CHEROKEE METROPOLITAN DISTRICT ELLCOTT CHLORINATOR UPGRADES EL PASO COUNTY, COLORADO SITE DEVELOPMENT PERMIT: PPR-XXXX

ELICOTT CHLORINATOR UPGRADES
CHEROKEE METROPOLITAN DISTRICT
EL PASO COUNTY, COLORADO
LEGEND, NOTES & ABBREVIATIONS
SHEET NO.
G0.1

ELLCOTT CHLORINATOR UPGRADES
CHEROKEE METROPOLITAN DISTRICT
EL PASO COUNTY, COLORADO
SITE DEVELOPMENT PLAN

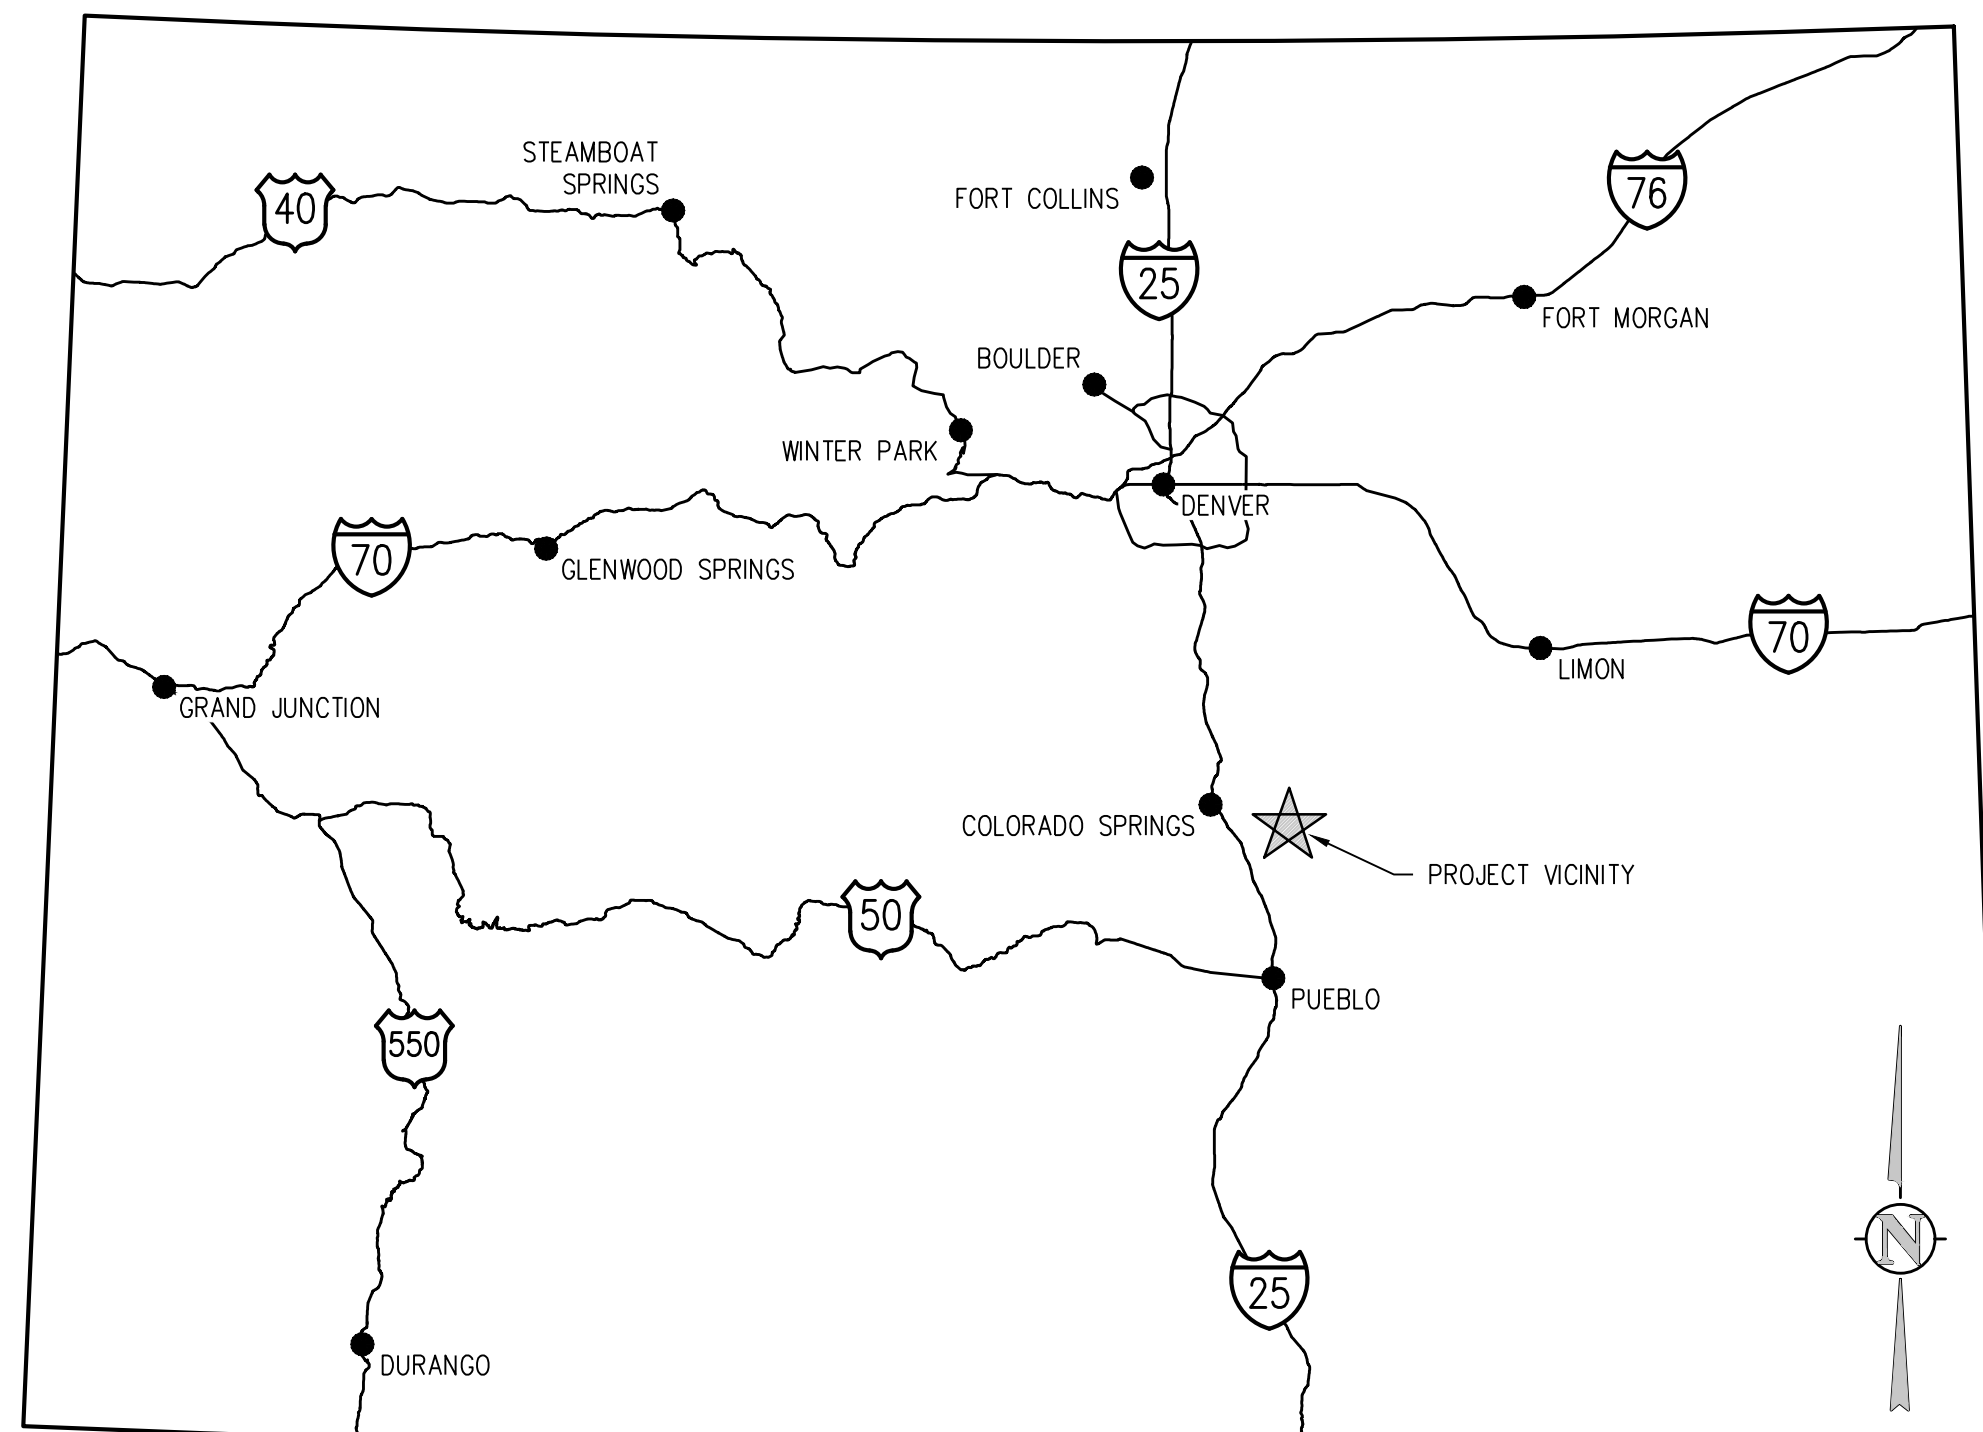
Remove Signature blocks as they are not required and the site development plan is not a document approved by the ECM Administrator.

SHEET NO.
C1.0

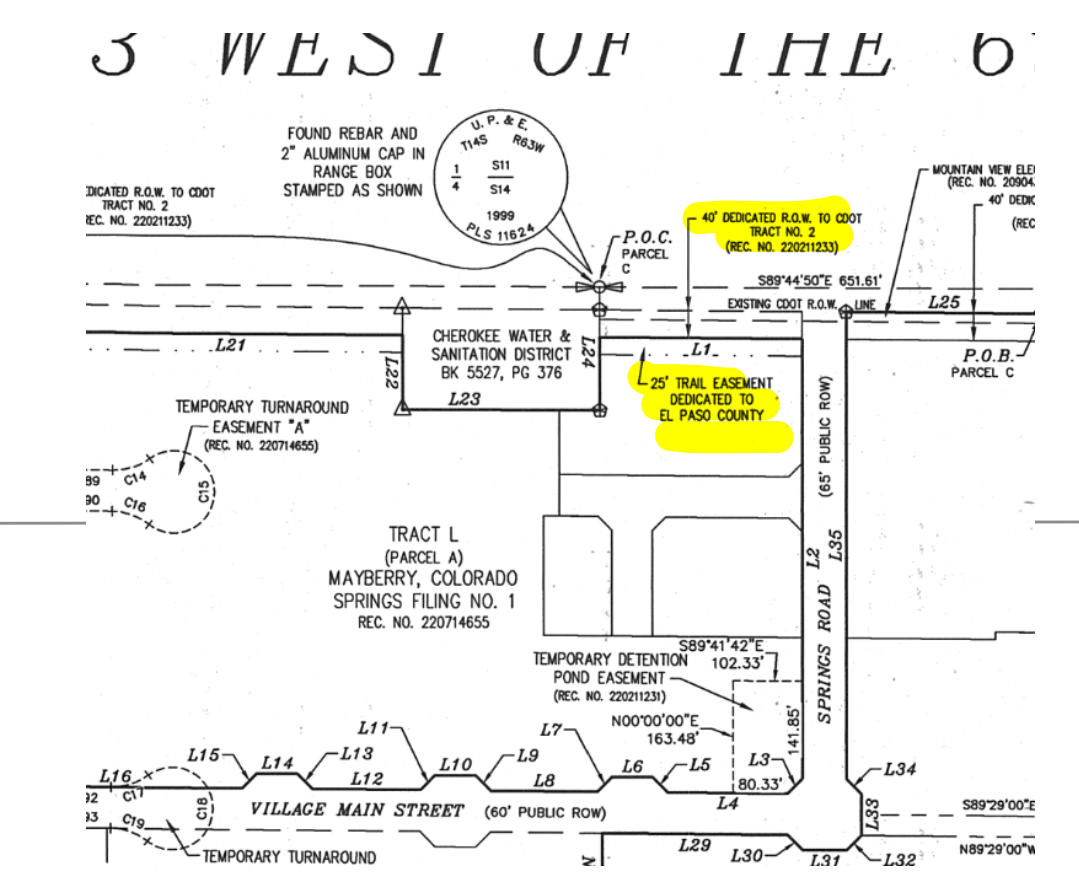
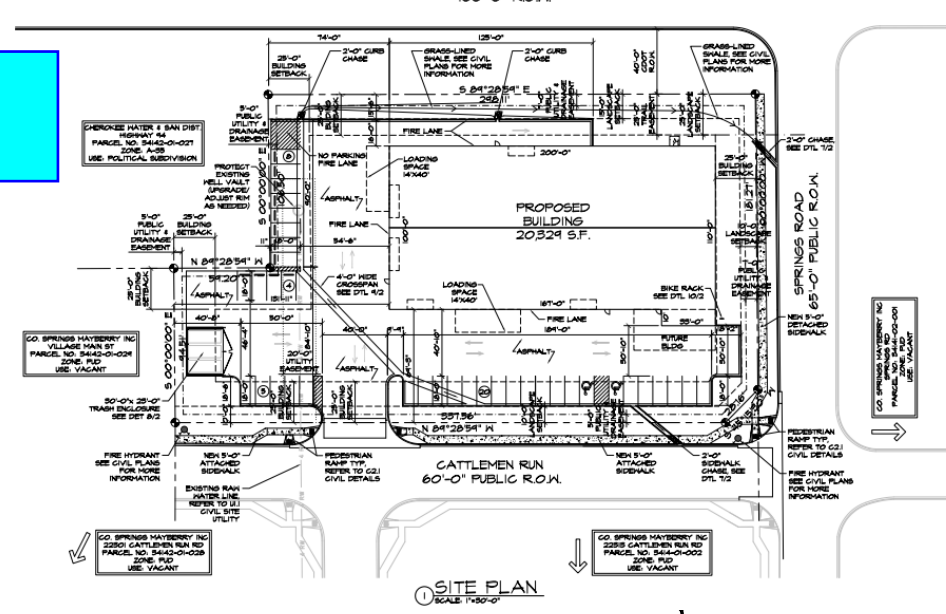
Please add file name
PPR-2334

Show complete access road
Submit for CDOT access permit and
provide copy of application email receipt
from CDOT or copy of existing access
permit.

Please show
setbacks of all
proposed and
existing structures

Please add square
footage for all
proposed
structures.

Denote specific
ROW width.
Contact CDOT as
necessary

Denote access to be
closed

label the existing
tract/parcel
dimensions. This
appears to go beyond
the one parcel

Show ROW and
easements that have
been dedicated

is this swale
proposed or existing.
Please identify what
is proposed and what
is existing.

Please clearly define
exact lot lines.

Show and call out all adjacent
parcels and tracts reflected from plat
#14698 or approved site plans
Its not clear what is being built on
which parcel or tract
Show all dedicated ROW and
easements along HWY94

Please clearly define
land swap lot lines. It
does not appear the
proposed water storage
tank will meet 25ft
setback requirements per
the A-35 zoning district.

An administrative relief
can be requested to meet
a 20ft setback, however
that is a separate
application.

Call out all
surface types
or provide
shading and
legend

label all areas and
components as existing
or proposed. Delineate
limits of construction.

This tank is not on the
parcel
